From: Thomas Alexion
To: BENNETT, STEVE A
Date: 11/13/02 3:18PM
Subject: VESSEL PHONE CALLS

SUMMARY OF VESSEL HEAD AND VESSEL BOTTOM PHONE CALLS

Request for Additional Information Related to Bulletin 2002-01 Arkansas Nuclear One, Unit 1 (ANO-1)

From: "BENNETT, STEVE A" <SBENNE2@entergy.com>
To: "Tom Alexion" <twalex@nrc.gov>
Date: 11/5/02 9:14PM
Subject: ANO-1 Draft Response to NRC Bulletin 2002-01

Reactor Vessel Skirt Openings and Locations Plan View – Looking UP

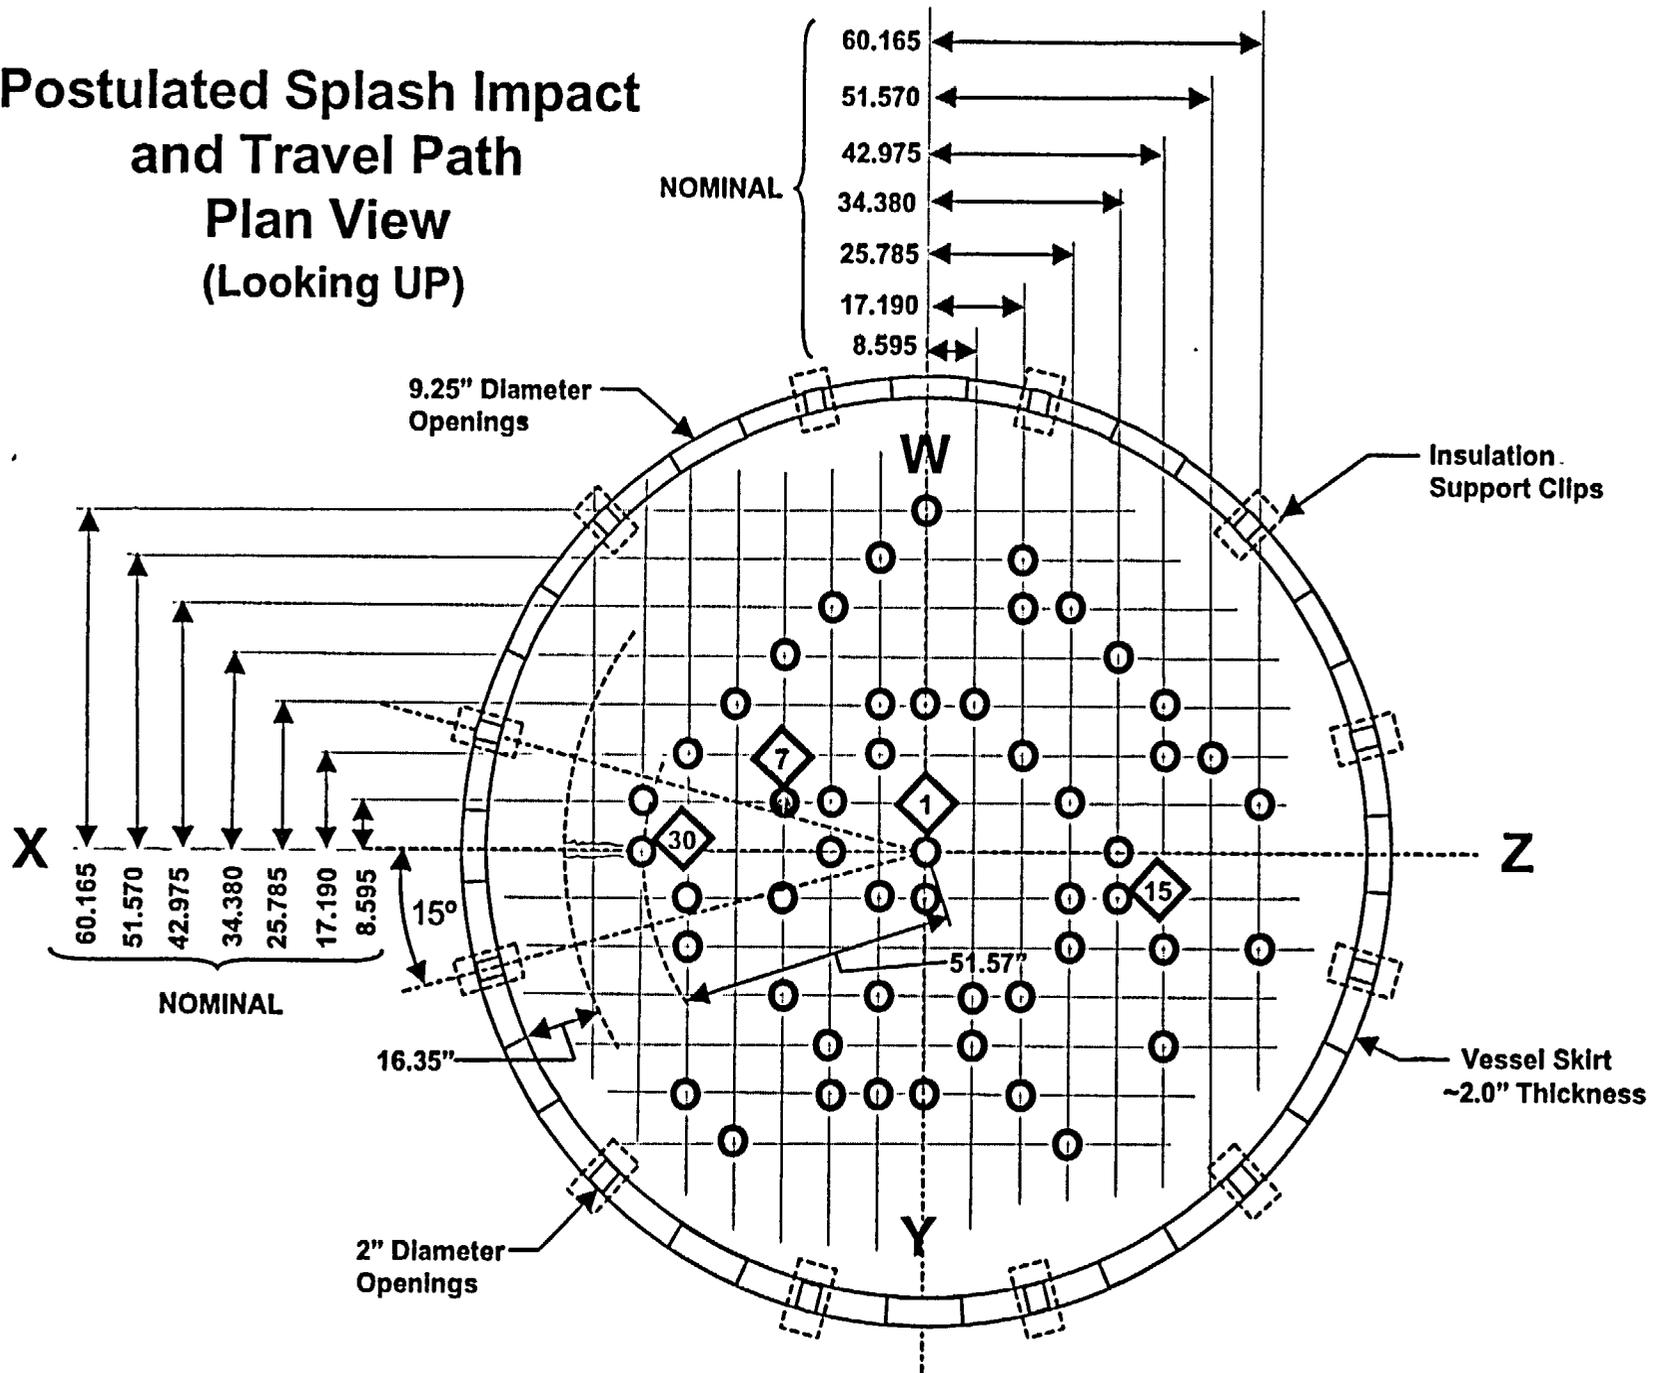
1. Provide detailed drawings and dimensions of the vessel bottom (including the vessel skirt, insulation, etc.) showing the instrumentation nozzles; include on these drawings the boric acid deposits (e.g., staining) based on information obtained from your videotapes. Show the nozzles in the vicinity of nozzle 30 down to nozzle 1, and in the vicinity of nozzle 15 down to nozzle 1.

2. Explain your best efforts to locate the source of the boric acid deposits. Address the feasibility of performing additional inspections of the annulus between the vessel/support skirt and the vertical insulation or from the under vessel area to provide further evidence of the path of borated water through the 2 inch support skirt openings.

Attachment 1 (Diagrams of penetrations through vessel skirt, nozzle layout, and description) identifies the nozzles that were inspected using a boroscope and the results. The four nozzles inspected by a boroscope were the only incore tubes that had staining below the insulation. The purpose of the boroscope inspection was to determine whether these nozzles had any evidence of leakage at the vessel interface. Attachment 2 provides a scale composite drawing showing the dimensions of the reactor vessel, support skirt, insulation details, and nozzle 1 and 30.

Based on discussions with site personnel (refueling team, operations, maintenance staff) that were familiar with past activities and issues in the reactor vessel area, instances of cavity seal plate leakage were identified as likely sources for the staining identified in the general area under the vessel. In order to understand the relationship of the vessel, the insulation, the concrete structure, and the drainage path for cavity seal plate leakage, the composite drawing previously identified was developed for this area. Additionally, it was determined that decontamination efforts of the transfer canal near the vessel flange area during the 1980's and early 1990's included rinsing fluid into the cavity seal plate area when the plate was not installed. During this time frame, cavity seal plate leakage was a fairly common occurrence as well as CRDM flange and RVLMS flange leakage decontamination efforts with the cavity seal plate removed. Also an overflow of the incore tank (R-8) that occurred in September 1999 was identified as a source for some of the boron residue identified on the floor in the area under the reactor vessel. Based on these reviews, probable flow paths have been identified that correspond to the indications seen. Documented inspections of the area under the vessel from the previous two outages to the present do not indicate any change in condition to this area.

The reactor cavity seal plate leakage would traverse the annulus area between the vessel and the mirror insulation to reach the undervessel area. The ability to perform additional inspections of the vertical annulus area between the vessel and the mirror insulation has been evaluated. To provide direct visual evidence of the path of borated water through the 2 inch holes in the support skirt above the undervessel insulation, access to the annulus would have to be gained. Possible access routes to inspect the area are limited to access from the top of the reactor vessel and access from below the vessel. There are no access locations between the top and bottom of the vessel because of the primary shield wall. The only openings through the shield wall are around the reactor vessel nozzles and these are too tight a fit to permit access. Access from the top of the vessel to the annulus between the shield wall and the reactor vessel is restricted by the reactor shield blocks. They consist of concrete filled, steel lined blocks. The shield blocks are located below the permanent seal ring at the top of the vessel and above the reactor vessel nozzles. These shield blocks provide a radiation shield in the annulus between the top of the reactor vessel and the floor of the refueling canal. There is no access through these blocks without removing them from above. This can only be accomplished by removing portions of the permanent seal plate.

The only other access to the area between the vessel skirt and the vessel insulation is from the bottom of the vessel. Access of this area is difficult to accomplish. One horizontal insulation panel in proximity to nozzle 30 could be removed to gain access to the area below the holes and a boroscope inserted through the area between the two adjacent incore nozzles, up to the accessible two (2) inch diameter holes located

Boroscopic Inspections of ICI Nozzles

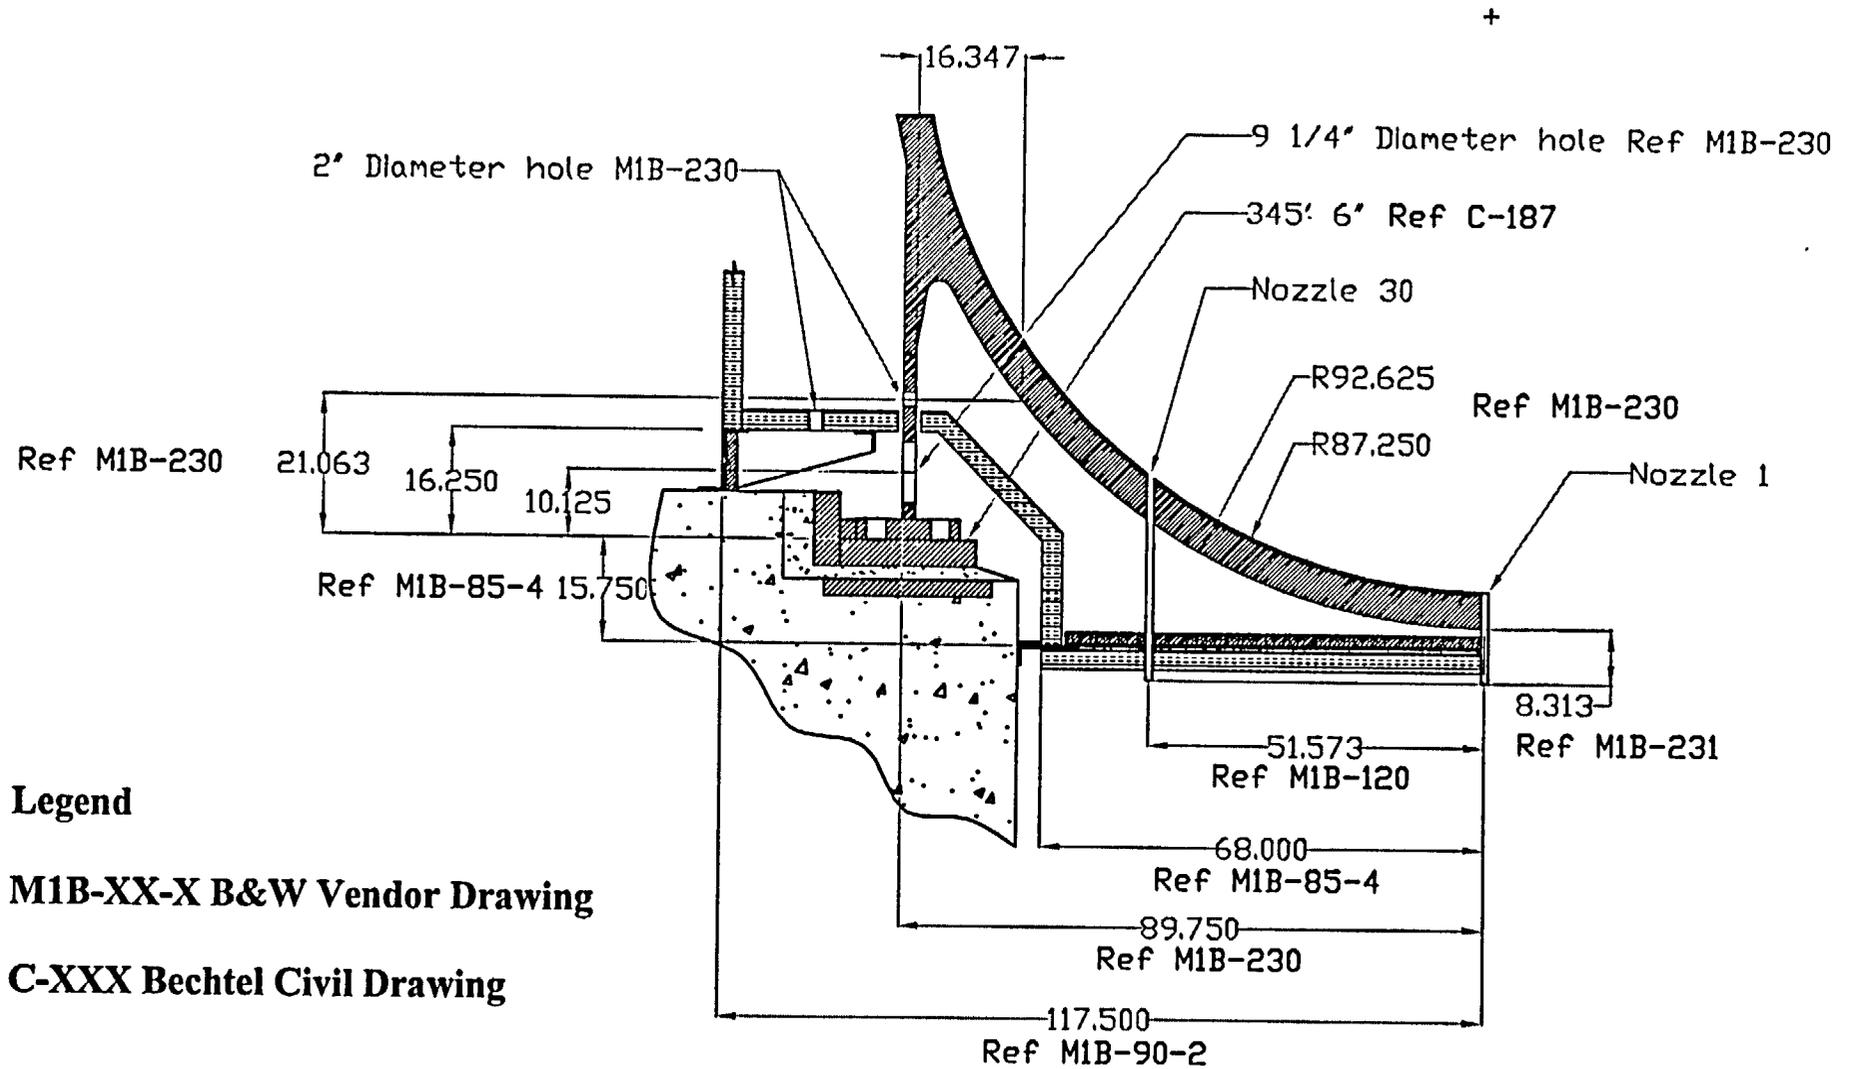
3. Characterize the boric acid deposits.
4. Describe what you see in the space between the vessel base metal and the outside diameter of the instrumentation nozzles.

The annuli between Nozzles 1 and 30 and the Rx vessel were inspected with a boroscope on 10/7/02, and the annuli of Nozzles 7 and 15 were inspected on 10/8/02.

In general, the vessel itself was noted to be relatively clean and in good condition, with uniform brown spotted discoloration of the silver-colored, high-temperature coating. The conditions noted were characterized as normal considering the age of the vessel. No "popcorn" type boric acid deposits or other typical boric acid accumulations were seen at or near the nozzles inspected. The condition noted during the inspection was generally faint white staining of the nozzle piping. Some light brown staining was observed on two nozzles but this is attributed to moisture external to the vessel. Limited boroscope video of the top side of the vessel insulation was obtained in the areas of nozzle # 15 and # 7. This video showed no staining or accumulation of boron on the insulation. The angle iron support structure for the insulation was very clean, with a few small widely spaced surface corrosion areas noted.

Two thin, faint white traces appear uphill, out of sight of the boroscope on the vessel and run to and down Nozzle 30. The traces appear less than a pencil width wide and are approximately 1 inch to 1.5 inches apart. Faint white staining of the nozzle piping is visible (approximately one to two pencil widths wide). These traces did not appear to be "active" sources, but rather appeared to be residue left over from a past occurrence when fluid may have gotten on and ran down the side of the vessel. A 360-degree close-up inspection of the nozzle shows no indication of boron originating from the annulus.

A single faint white stain can be seen of the nozzle piping just below the vessel, extending down below the insulation. The stain appears to be approximately a pencil width wide. A 360-degree close-up inspection of the nozzle shows no indication of boron originating from the annulus.

Two very small, very thin, brown traces extend down the nozzle pipe, one approximately 2" to 3" long. The other trace extends approximately 1/2" down the pipe. The traces are 1/2" apart. Numerous small individual stain spots are visible on one side of the nozzle piping, approximately 120 degrees around from the brown traces. These spots appear to be dried residue from moisture droplets. A 360-degree close-up inspection of the nozzle shows no indication of boron originating from the annulus.

Faint white staining is visible on the nozzle piping extending from the vessel down through the insulation to below the insulation. The stain ranges in width from 1/4 to 1/2 the circumference of the nozzle pipe. Some barely noticeable brown staining is visible on the nozzle piping (approximately 1 pencil width wide. A 360-degree close-up inspection of the nozzle shows no indication of boron originating from the annulus.
